DRAWING AMENDMENTS

Appl. No. 10/021,531
Amdt. For Reply to Office Action Dated August 13, 2003
REPLACEMENT SHEET

Figure 2

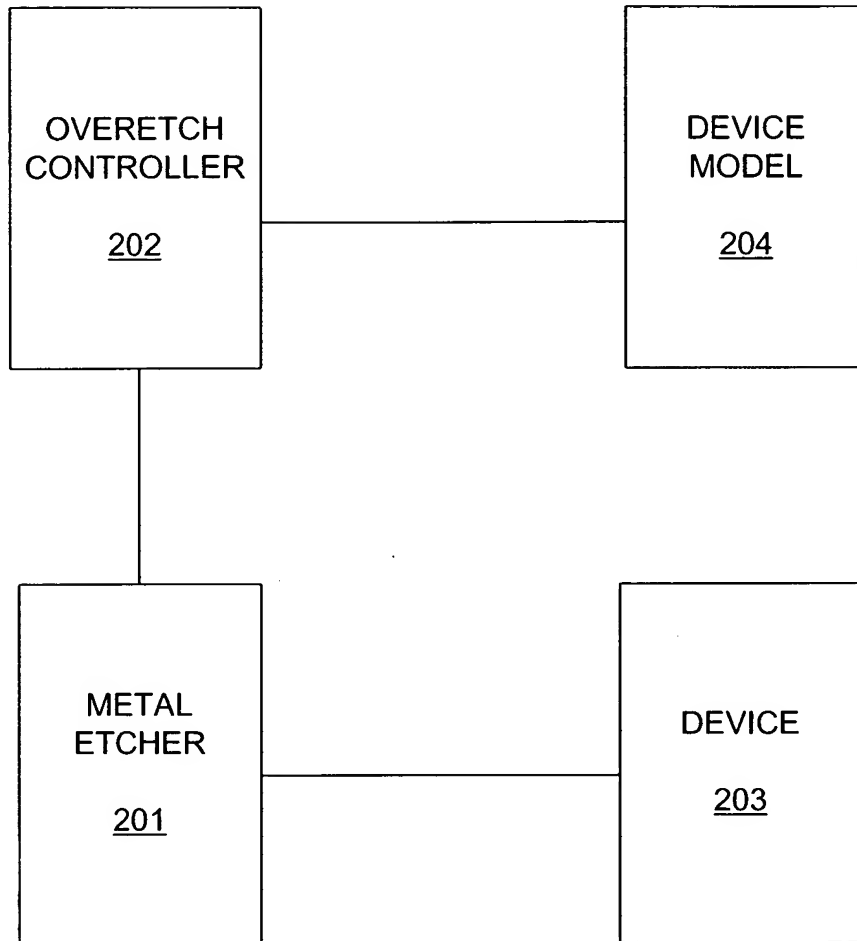
The attached drawing sheet includes a change to Figure 2. This sheet replaces the original sheet including Figure 2. Figure 2 is being amended to make it consistent with the specification. In particular, block 202 labeled "OVERETCH SYSTEM" has been changed to read "OVERETCH CONTROLLER."
